February 14, 1992
LD-92-020

Subject: Response to NRC Requests for Additional Information

RESPONSE TO NRC REQUESTS FOR ADDITIONAL INFORMATION
REACTOR SYSTEMS BRANCH

Figure 5.2-1 SYSTEM 80+ MASS ADDITION TRANSIENT
(INADVERTENT SAFETY INJECTION ACTUATION)

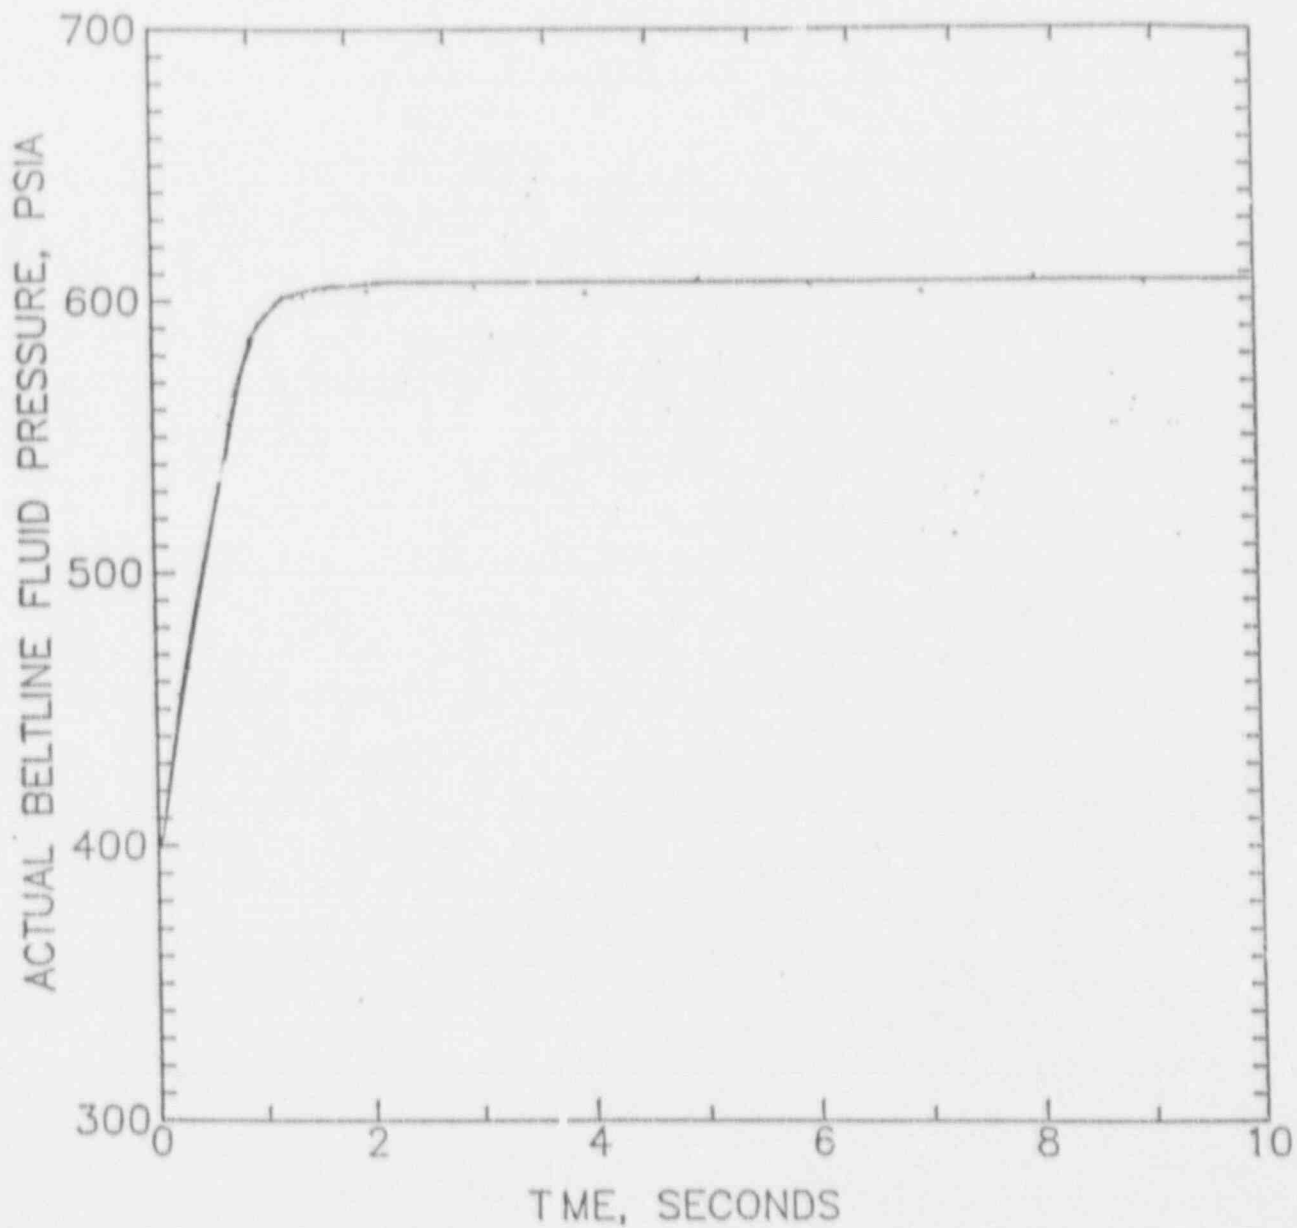
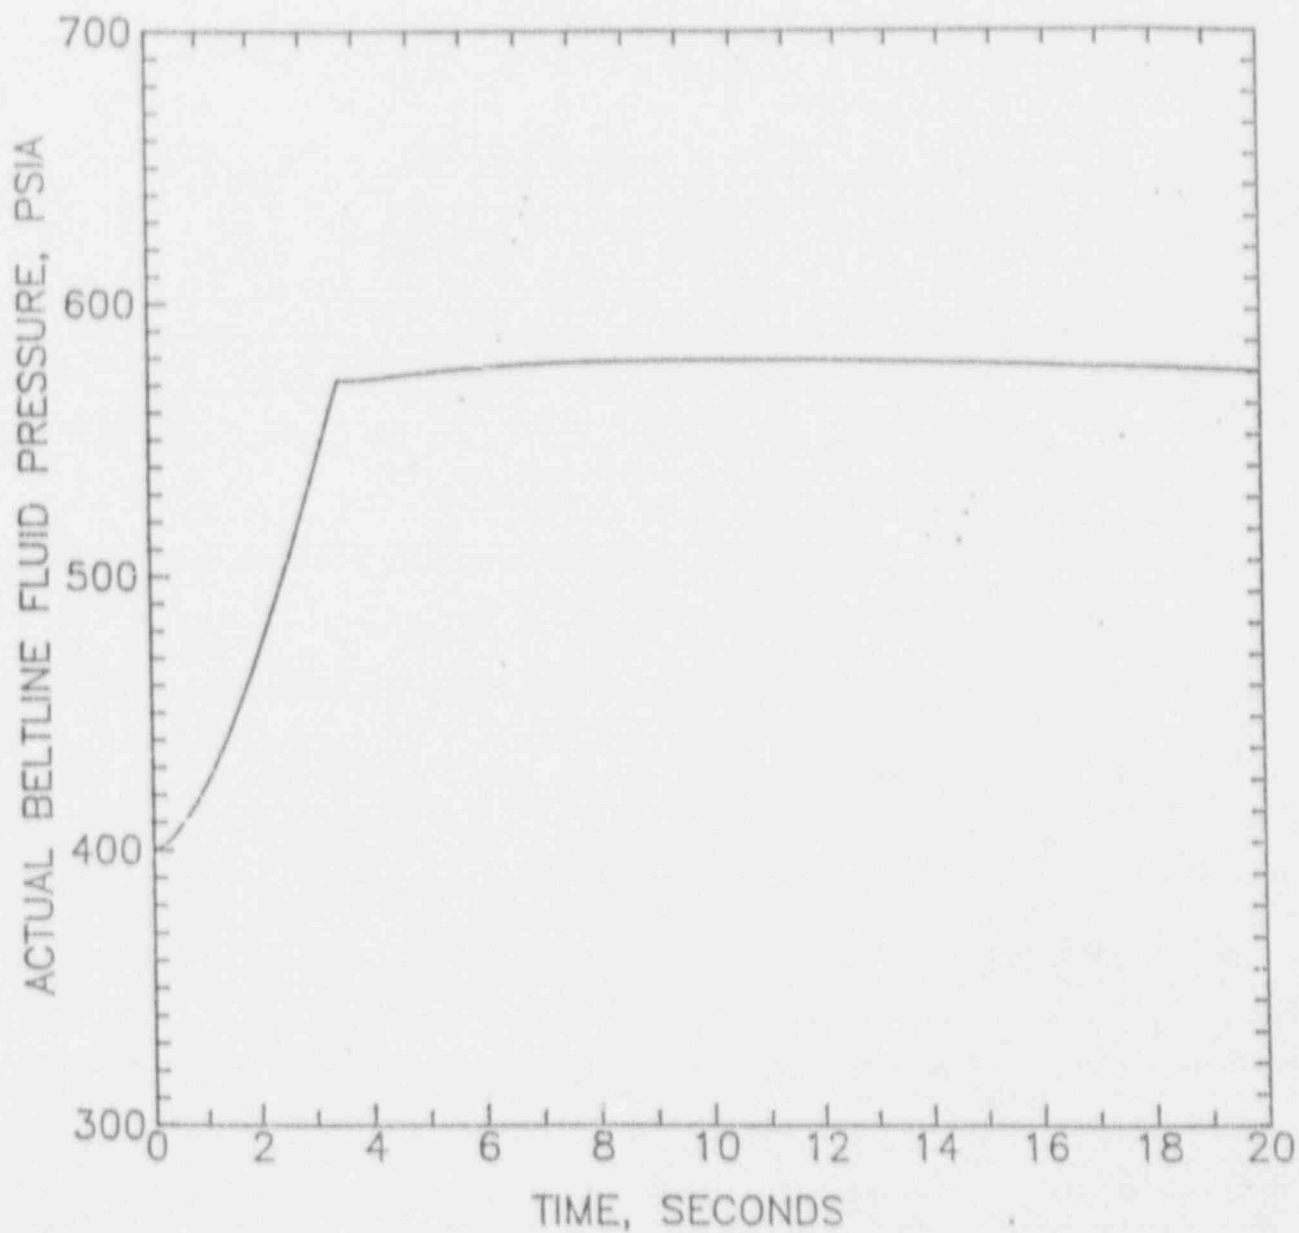
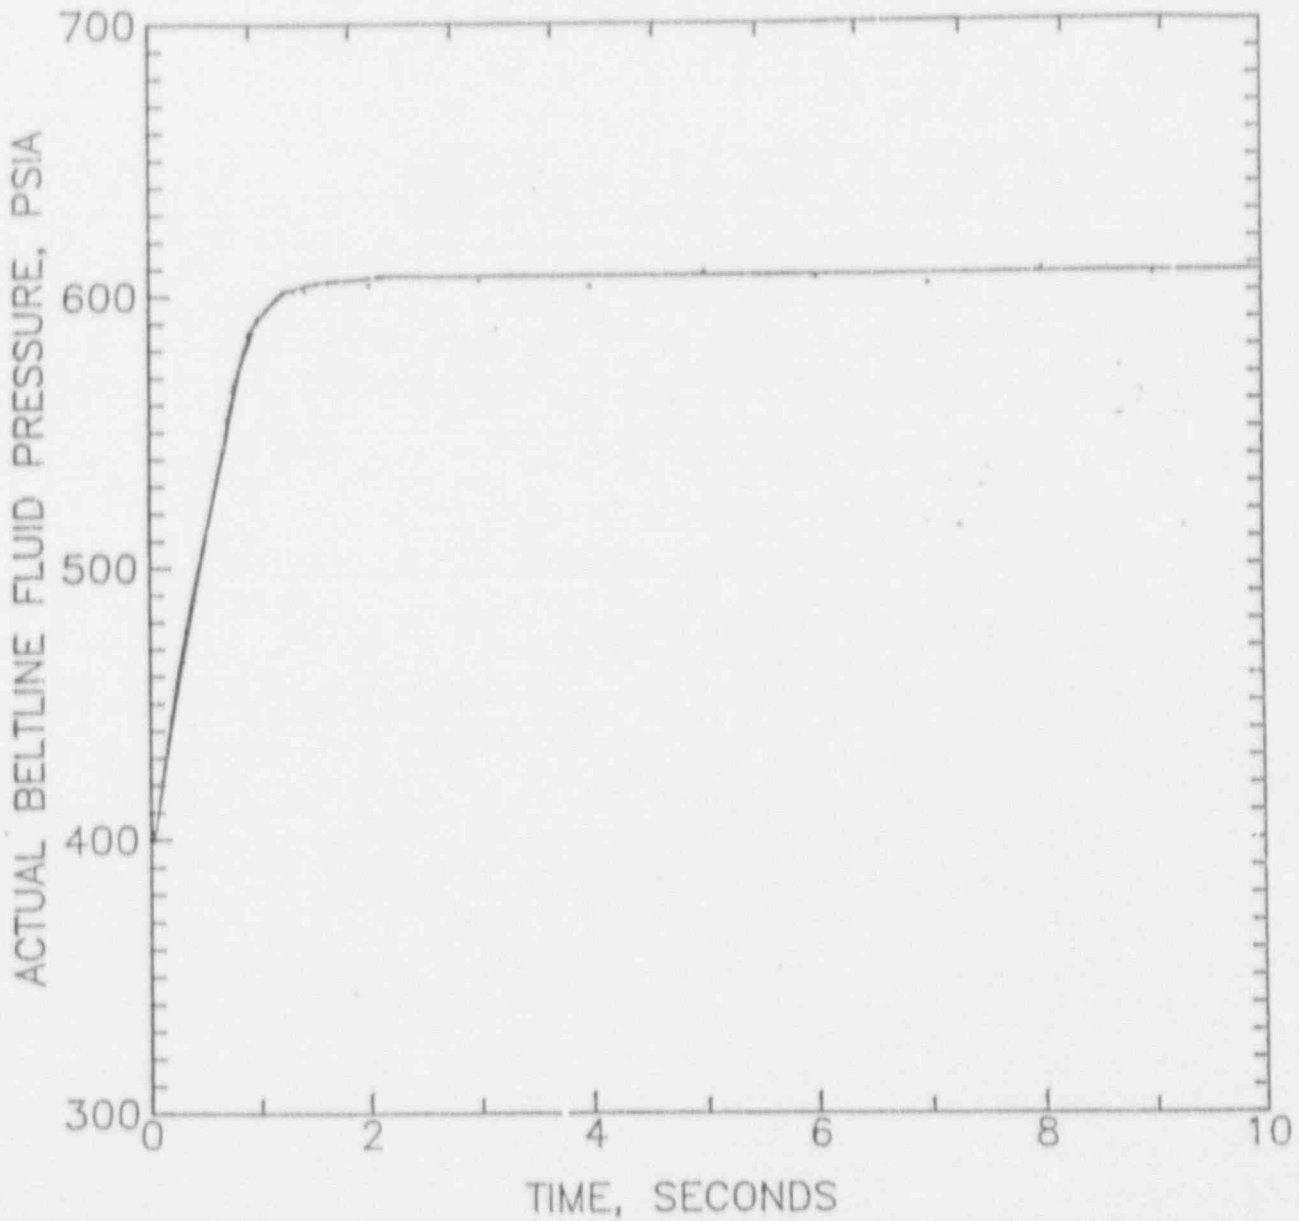
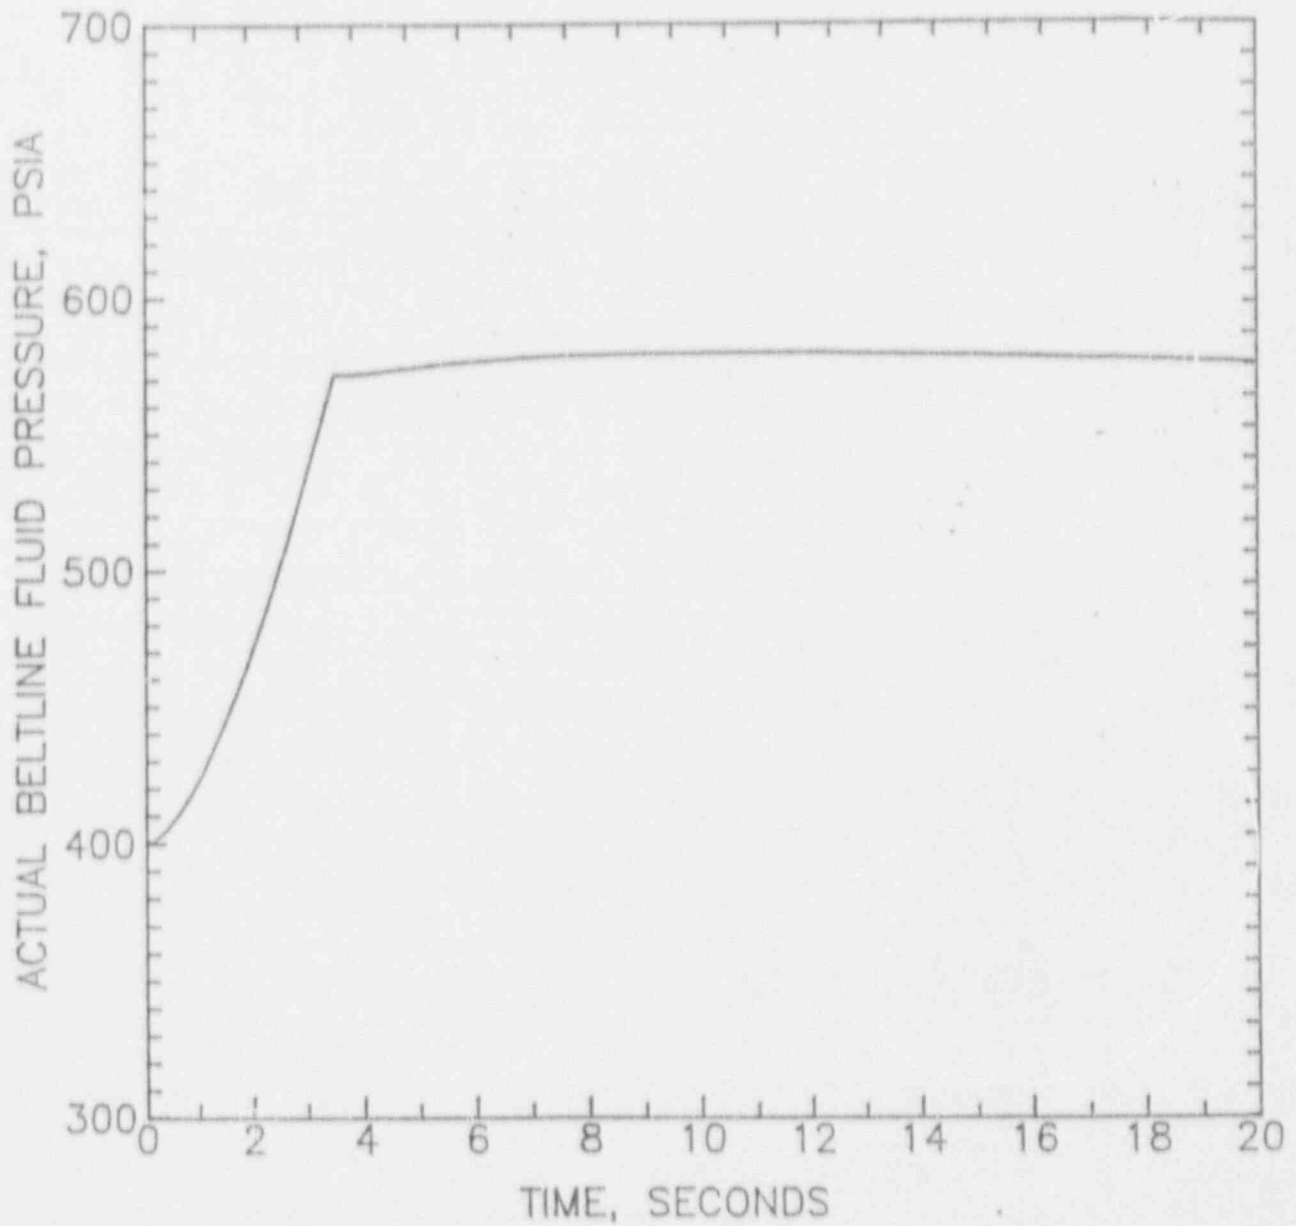
Provide the results of the analyses for the design basis mass addition and energy addition transients including transient curves that demonstrate the peak RCS pressures are within pressure temperature limits determined for the System 80+ design. Instrumentation uncertainties should be factored into your evaluation.

The results of the design basis mass addition and energy addition transients are attached and will be included in CESSAR-DC Chapter 5 section 5.2.2.10. These figures will appear in a future amendment to CESSAR-DC.

Figure 5.2-2 shows the result of the transient analysis of reactor coolant pump start when a steam generator to reactor vessel ΔT of 100°F exists. This ΔT is the maximum allowed by technical specification during the LTOP mode. In addition to considering the energy addition to the RCS from the steam generator secondary side, energy addition from decay heat, the reactor coolant pump and all pressurizer heaters were also included. In this analysis the steam generators were assumed to be filled to the zero power, normal water level. For conservatism, the secondary water, both around and above the U-tubes, was assumed to be thermally mixed in order to maximize the energy input to the primary side. This assumption is conservative since as a result of the temperature distribution within the steam generator during the transient, the water inventory above the tubes is practically isolated thermally from the heat transfer region. Therefore the heat transfer rate, and thus the primary side pressure, is not sensitive to the secondary side water level as long as the tubes are covered.

Either SCS relief valve will provide sufficient relief capacity to prevent any pressure transient from exceeding the isolation interlock setpoint (see Figure 5.2-1 and ~~Table 5.2-3~~ Figure 5.2-2)

Replace with new
Figure 5.2-1

Replace with next
Figure 5.2-2

Figure
9.3.4-1

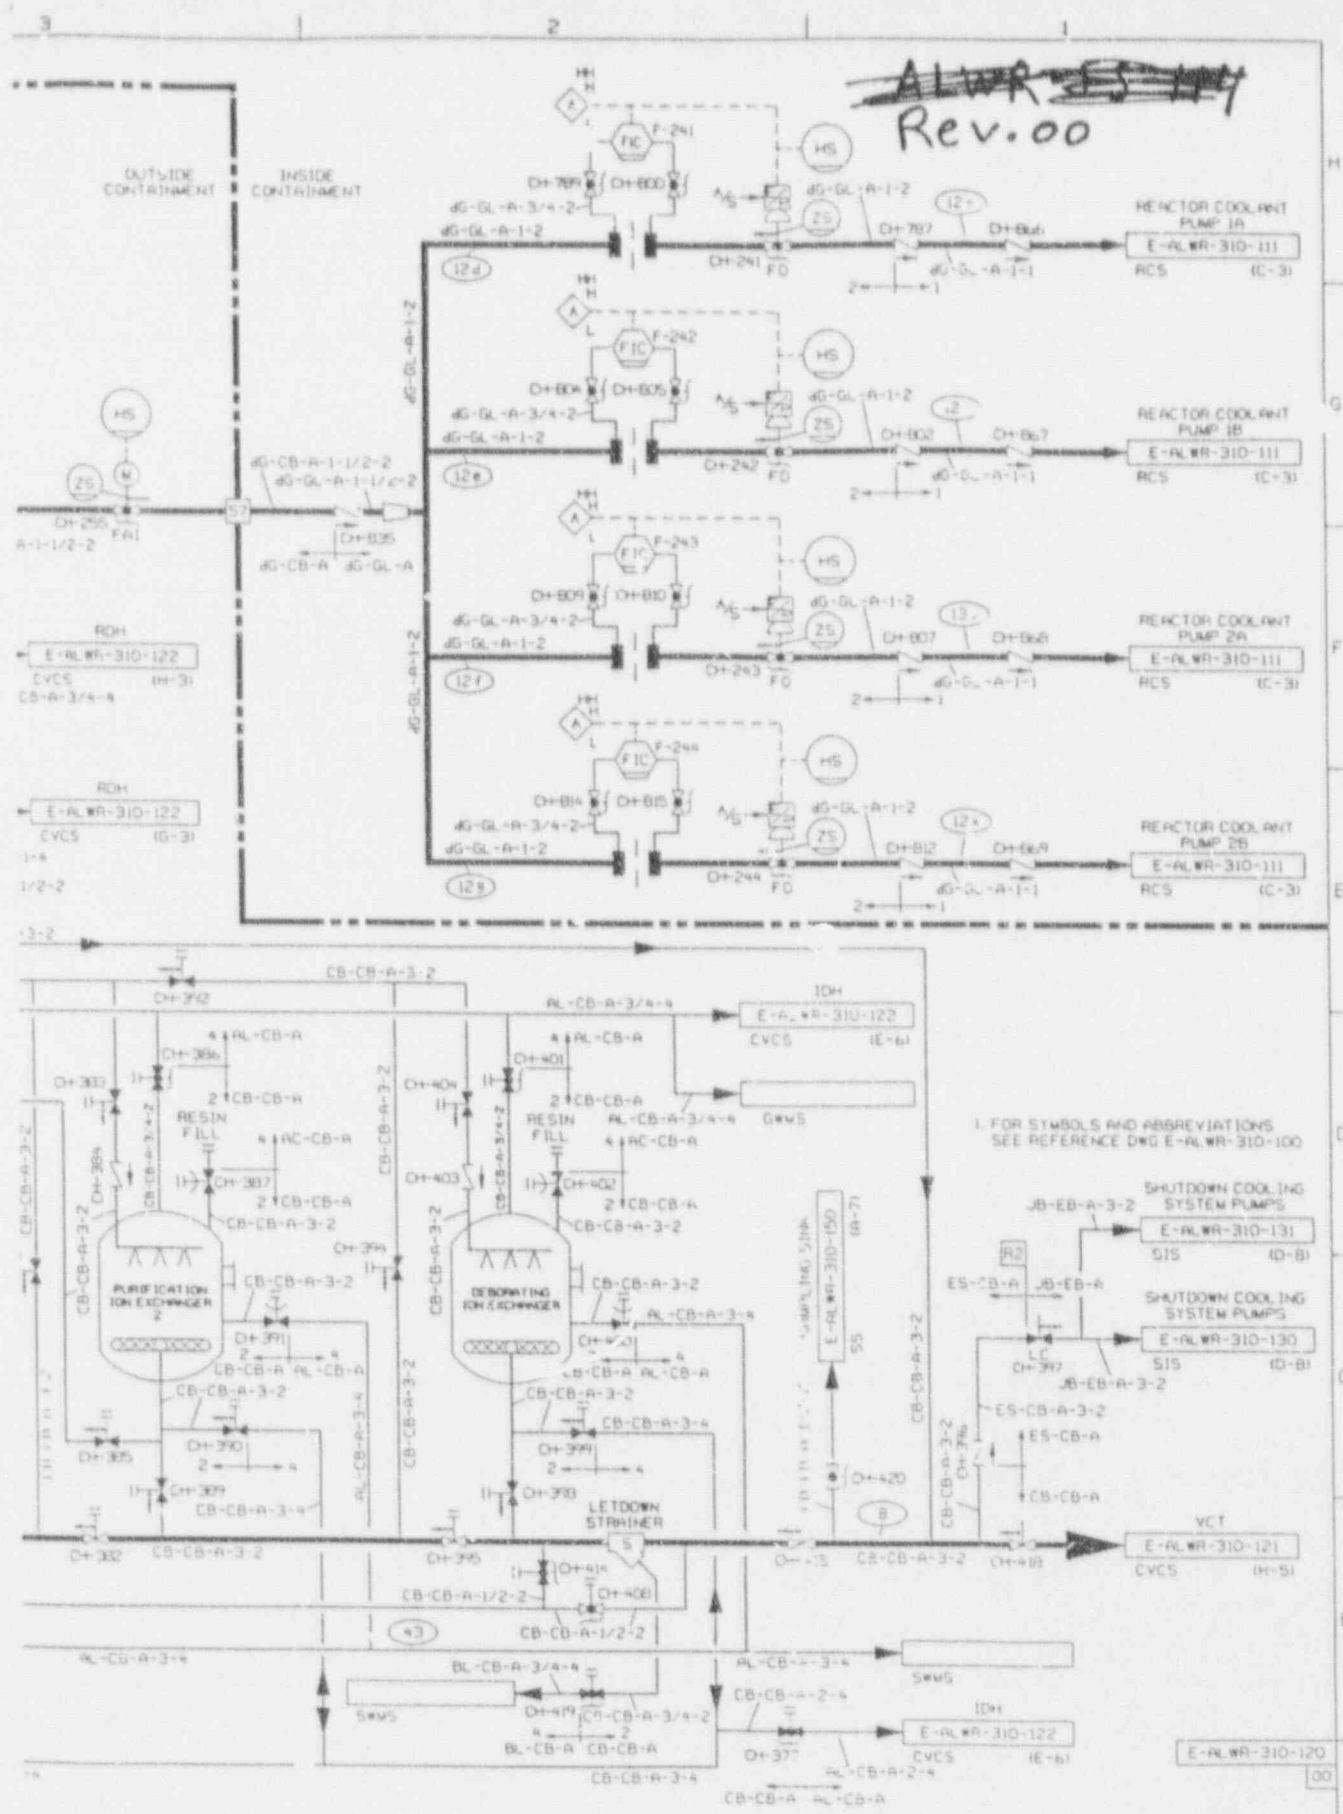
Our initial review of System 80+ design features, including proposed resolution of generic safety issue GI 105, does not provide adequate information on how these systems will satisfy the above staff position for evolutionary ALWRs. Please provide detailed discussion of how the System 80+ design meets the above criteria. As part of the response include:

This discussion refers to CESSAR-DC Figure 9.3.4-1, Sheets 1 and 2. Sheet 1 has been marked up to reflect revisions which will be incorporated into the next Amendment to CESSAR-DC. This sheet is attached for information. Sheet 2 can be found in CESSAR-DC. The P&ID coordinates for the valves listed below are provided in Table 440.45-1 of this response.

The letdown orifices (Sheet 1 of Figure 9.3.4-1, coordinates F-7) limit letdown flow to its maximum allowable value if the letdown control valves are fully open. The orifices are located in containment, upstream of the outer containment isolation valve (CH-523) in piping designed to RCS design pressure. The letdown line relief valve (CH-354) is located downstream of the letdown control valve isolation valves. CH-354 has a capacity equal to the capacity of the letdown orifices with the letdown control valve fully open. Overpressurization protection is thus provided for portions of the letdown flowpath designed to a pressure less than design pressure.

Auxiliary Spray Line -- The auxiliary spray line (at coordinates H-7 and H-6 on Sheet 1 of Figure 9.3.4-1) is a path parallel to the charging line. It has the same piping design pressure rating and the same design configuration as the charging line. Five check valves in series separate the charging pump suction piping from RCS pressure. As stated above, it is implausible that the charging pump suction piping could be overpressurized by the RCS.
